WATTS BAR NUCLEAR PLANT (WBN) – LICENSE AMENDMENT (WBN-TS-03-12)
MONITORING OF CONTROL OR SHUTDOWN ROD POSITION BY AN ALTERNATE MEANS
- REQUEST FOR ADDITIONAL INFORMATION (RAI) (TAC MC 1419)

TENNESSEE VALLEY AUTHORITY
WATTS BAR NUCLEAR PLANT (WBN)
UNIT 1
DOCKET NUMBER 390

PROPOSED LICENSE AMENDMENT REQUEST WBN-TS-03-12
RESPONSE TO NRC'S REQUEST FOR ADDITIONAL INFORMATION (RAI)

Figure 1
Example of Wiring for the Monitoring of Rod Control System Parameters
Example Based on Control Rod E-5

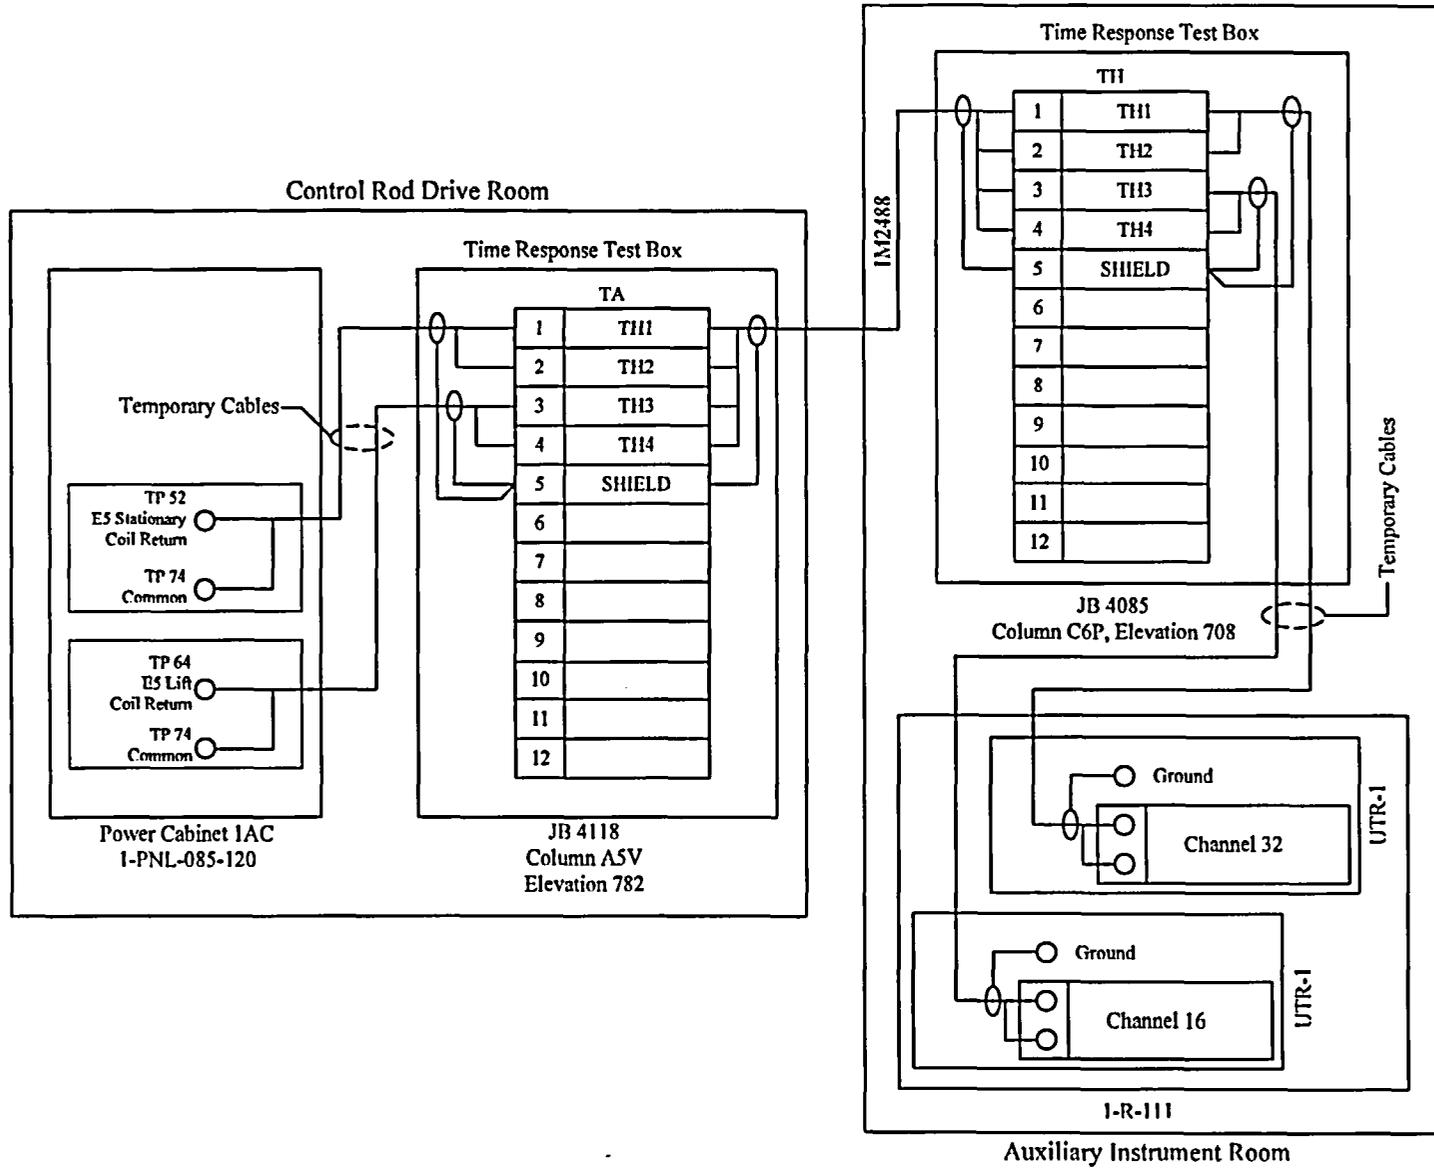
Provide a detailed description of the functions provided by the software algorithm used to support the alternate monitoring process.

In order to monitor if the affected rod stepped in the direction that was demanded, the method of implementing the alternate means was modified from that documented in TVA's initial amendment request. Figure 1 (below) documents the changes that were made to the monitoring circuit which adds the capability to monitor the current of the lift coil using a circuit similar to the circuit used to monitor the stationary gripper coil. The timing of the lift coil energizing will be analyzed by a software algorithm, and compared to demand signals generated by the rod control system to determine if the rod stepped in the direction demanded.

For any of the following three situations, the software algorithm will generate a plant computer alarm:

1. The rod stepped in the wrong direction.
2. The rod stepped with no demand (whether in automatic or manual control).
3. The alternate monitoring circuit fails.
